**Title: BRIEFING ON STATUS OF DOE HIGH LEVEL
 WASTE VIABILITY ASSESSMENT**

Date: Tuesday, March 16, 1999

6 BRIEFING ON STATUS OF DOE HIGH LEVEL WASTE
7 VIABILITY ASSESSMENT

MAJOR COMMENTS

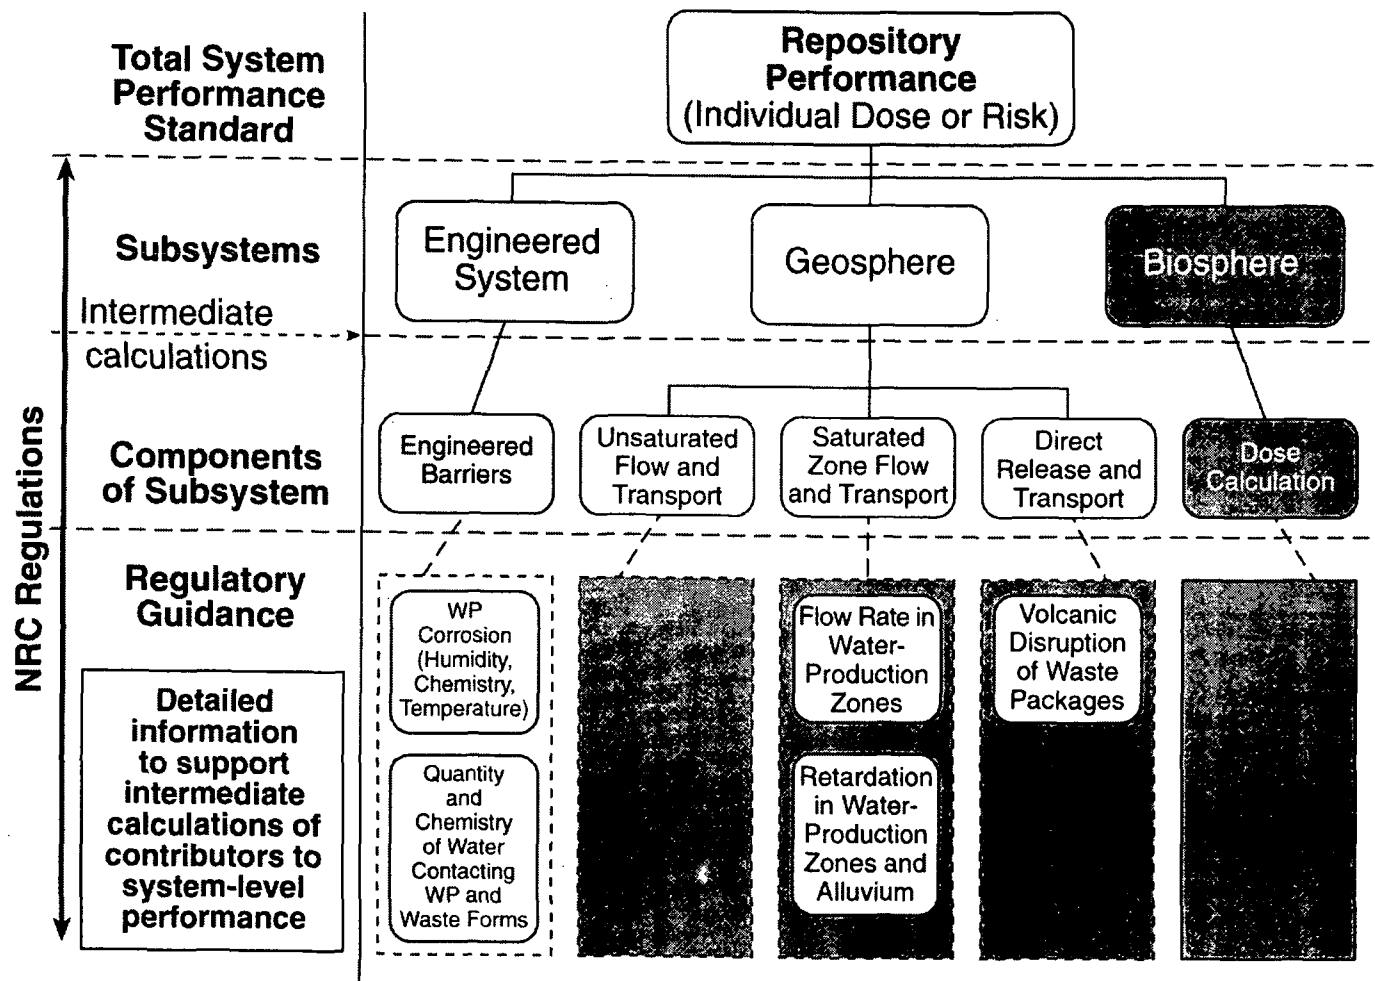
- **Preliminary Design Concept**
 - **Reference Design Provided but Many Significantly Different Alternatives Under Active Consideration**
 - **May not Converge Quickly Enough to Support Safety Case for LA**

TSPA Model Components

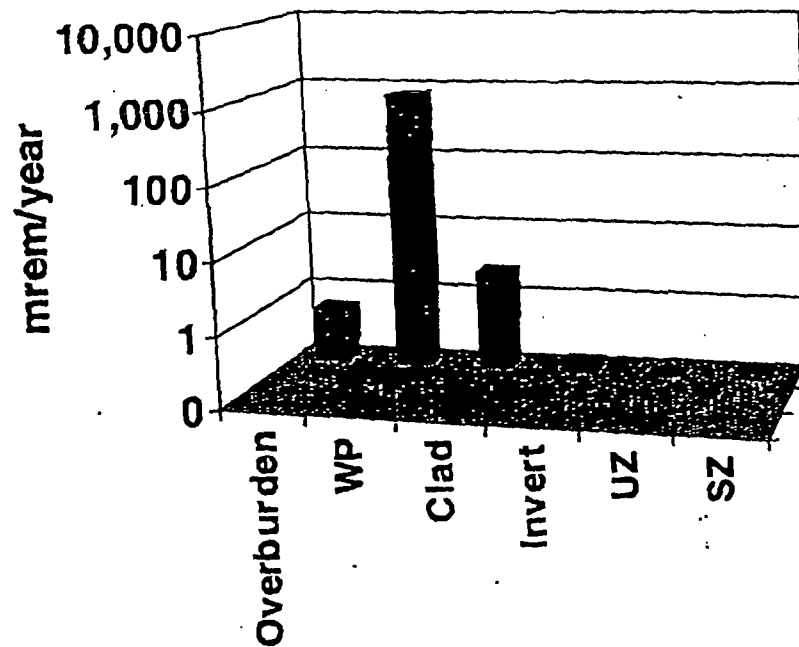
21 The first figure that is attached to our
22 presentation -- and I didn't use them as viewgraphs, but
23 they are in the back of the presentation -- illustrates
24 DOE's view of infiltration, waste mobilization and transport
25 in the Yucca Mountain repository system.
